**Subject: MHI's Response to US-APWR DCD RAI No. 313-2361 Revision 2**

**MHI's Response to US-APWR DCD RAI No. 313-2361 Revision 2**

**US-APWR Design Certification  
Mitsubishi Heavy Industries  
Docket No. 52-021**

**RAI NO.:** NO. 313-2361 REVISION 2  
**SRP SECTION:** 15.04.08 – SPECTRUM OF ROD EJECTION ACCIDENTS (PWR)  
**APPLICATION SECTION:** 15.4.8  
**DATE OF RAI ISSUE:** 5/04/2009

Figure 15.4.8-6.1 Missile Shield and CRDM

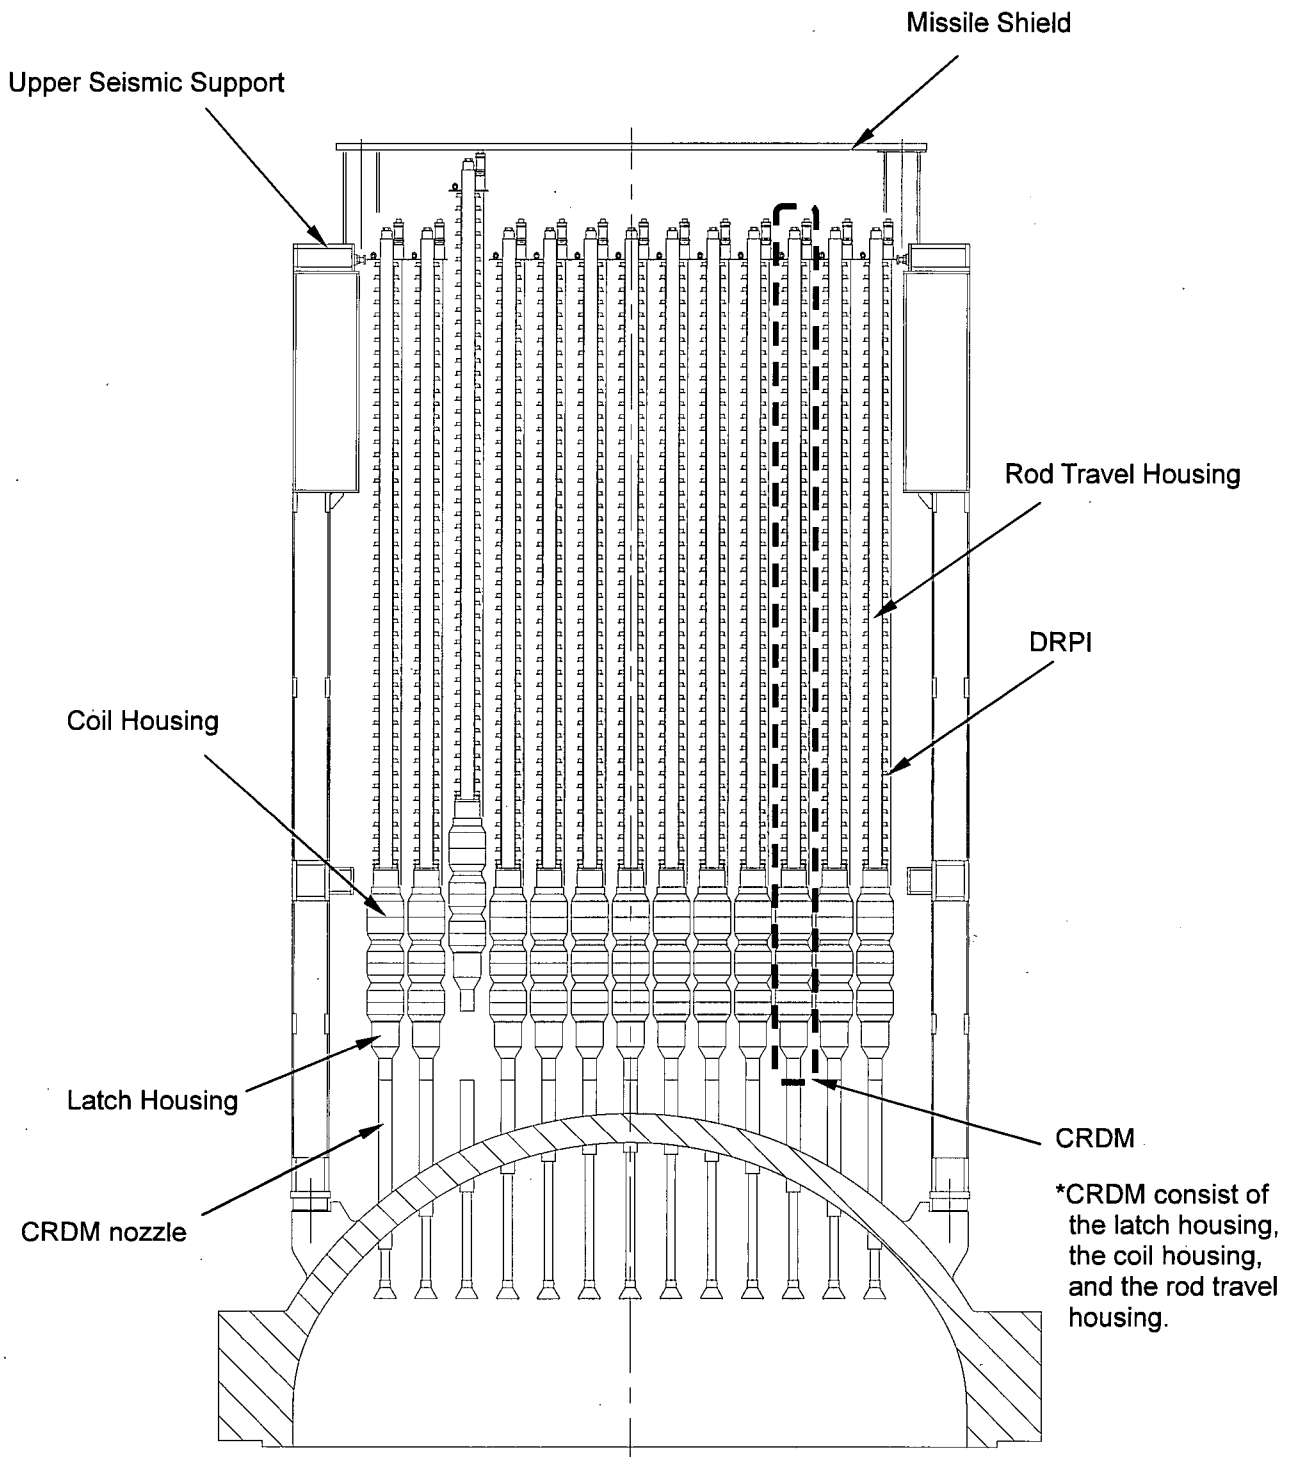
Provide drawings of the missile shield which dissipates the ejected CRDM's kinetic energy. Also, provide analysis to demonstrate that the CRDM's resulting kinetic energy upon deflection is sufficiently low so as to not cause the failure of a neighboring housing.

The missile shield is installed to the upper seismic support as shown below in Figure 15.4.8-6.1. Even if a CRDM missile occurs due to the failure of the CRDM nozzle welding, the collision of the top of rod travel housing with the missile shield can limit the uplift of the coil housing to approximately ( ) inches, even though the CRDM is uplifted. On the other hand, the radial gap between coil housings placed in the CRDM is narrow, around ( ) inches. The missile shield prevents a coil housing from passing through the narrow gap area and limits the radial movement, which results in nearly vertical missile energy. Therefore, the impact load applied to the neighboring CRDM housing is sufficiently low so as to not cause the failure of a neighboring housing.
